# McLaren 720S – WCAC Pipe to HVAC Pipe Clash Rework

**Bulletin type:** Service Campaign Bulletin  
**Reference number:** SCB14 L 002  
**Campaign reference:** 04V  
**Attention:** Retailer Service Managers and Retailer Technicians  
**Affected vehicles:** McLaren 720S; Coupe and Spider  
**Situation:** Potential for insufficient gap tolerance between components  
**Procedure:** To action affected vehicles during next Retailer visit  
Please refer to the information outlined in this document to ensure sufficient gap tolerance is created between mentioned components  
**Date:** 5<sup>th</sup> September 2019

Layout overview - Install clip assembly (5) and move pipe protector

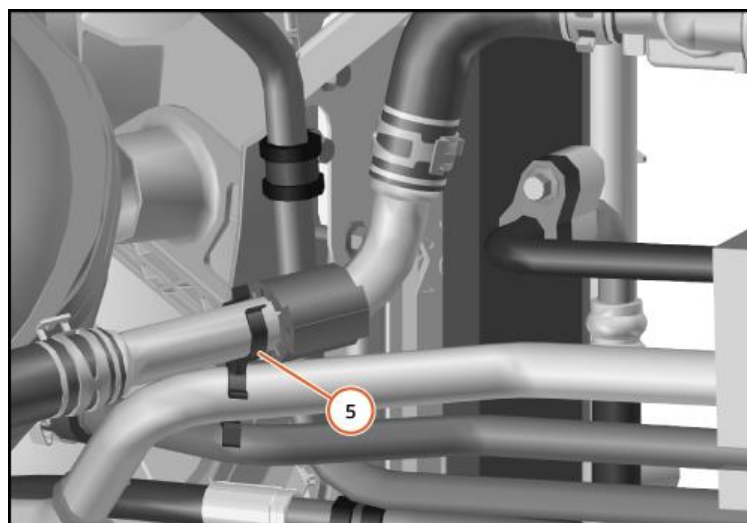
McLaren Automotive has identified through our continuous product quality monitoring, that several McLaren 720S vehicles (Coupe and Spider versions) may have an insufficient gap tolerance between a Water Charge Air Cooler (WCAC) pipe and Heating Ventilation Air Conditioning (HVAC) pipe. This could cause a clash condition and subsequent damage to the components.

To carry out the required re-work, repositioning of the existing pipe protector is required along with installation of a double 'C' clip which will increase the gap tolerance and prevent further potential clashes.
